# Intel<sup>®</sup> 5100 Memory Controller Hub Chipset

Specification Update

**Revision 008US**

Order Number: 318385-008US

**41. Incorrect CKE behavior during recovery from S3 suspend**

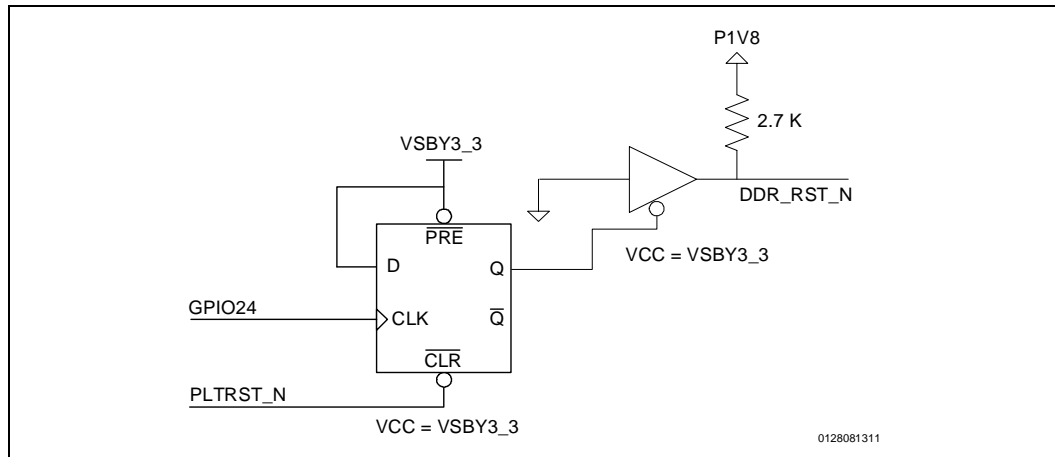
**Problem:** During the initial stage of exit from System Sleep State “S3” (suspend to RAM), the CKE signal is driven to an indeterminate state (High, Low, or tristate).

**Workaround:** The workaround requires both a board-level circuit and a BIOS change. The workaround holds the DIMMs in reset using a flipflop clocked by a GPIO from the ICH9R under control of the BIOS. An output controlled buffer is also required to transition the 3.3 V output of the flipflop to the 1.8 V reset input of the DIMM (see diagram below). The possible GPIOs are GPIO[28,27,24,12]. The GPIO implemented in the circuit is incorporated into the BIOS as a build option by an Intel BIOS Vendor (IBV).
